AMENDMENT UNDER 37 C.F.R. § 1.111  
U.S. Appl. No. 10/066,638

**AMENDMENTS TO THE DRAWINGS**

FIG. 3B

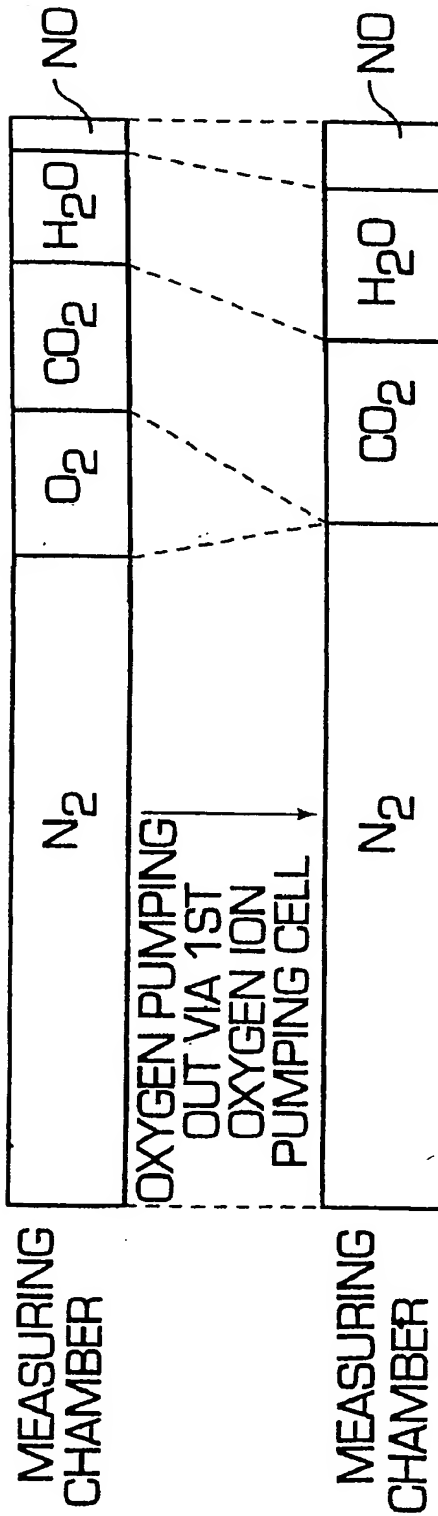
A replacement sheet for Fig. 3B is submitted herewith. Fig. 3B is amended to show oxygen in the first measurement chamber as introduced from the detection gas, which is pumped out by the first oxygen ion pumping cell. The N<sub>2</sub> bar is reduced correspondingly. The amendment to the drawing conforms to the description at page 19, lines 9-12 and at page 26, lines 6-12 of the specification. No new matter is added.
